ORDINANCE 25-17

AN ORDINANCE TO AMEND ORDINANCE NO. 22-24, BY AMENDING USE, DESIGN, AND DEVELOPMENT STANDARDS AND THEREBY BEING A TEXT AMENDMENT OF ORDINANCE 22-24

RZN 1827-2025 (LEGACY POINTE HEAVY RETAIL)

RE: Request to amend Legacy Pointe Planned Development

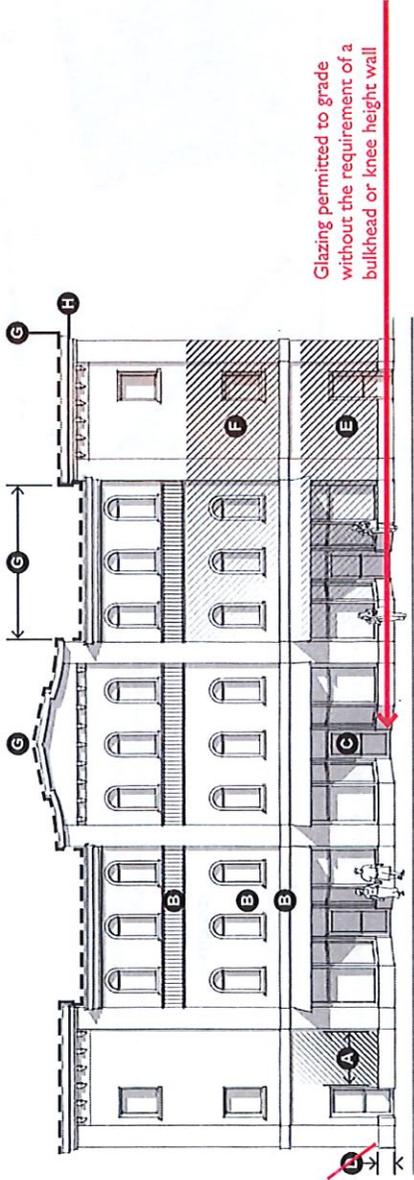
A Street abutting building façades must not contain blank wall areas that exceed 15 linear feet, measured parallel to the street.

B Street abutting building façades in excess of 100 feet must include a repeating pattern with no less than two elements, such as color change, texture change, material module change, or articulation of no less than ~~two~~ 12 feet in depth, such as a reveal, pilaster, or projecting rib. Elements must repeat at an interval of ~~40 to 60~~ 50 feet.

C All buildings must have a public entrance from the sidewalk along the primary building frontage. Ground floor entrances must be visually distinctive or prominent on the building façade. Ground floor building entrances may be recessed no more than six feet ~~from the required front building zone~~ and must be no wider than ten feet. ~~A building entrance must be provided at an interval of no less than one every 40 feet.~~

D ~~A bulkhead or knee height wall a minimum of 48 inches and a maximum of 24 inches in height is required along any street abutting façade.~~

E ~~In the C-D-E District, the ground floor must maintain a minimum transparency of 50%, measured between a minimum two and ten feet in height from grade.~~

F ~~In the C-D-E1 and C-D-E2 Sub-Districts, the ground floor must maintain a minimum transparency of 50%, measured between at minimum two and ten feet in height from grade.~~
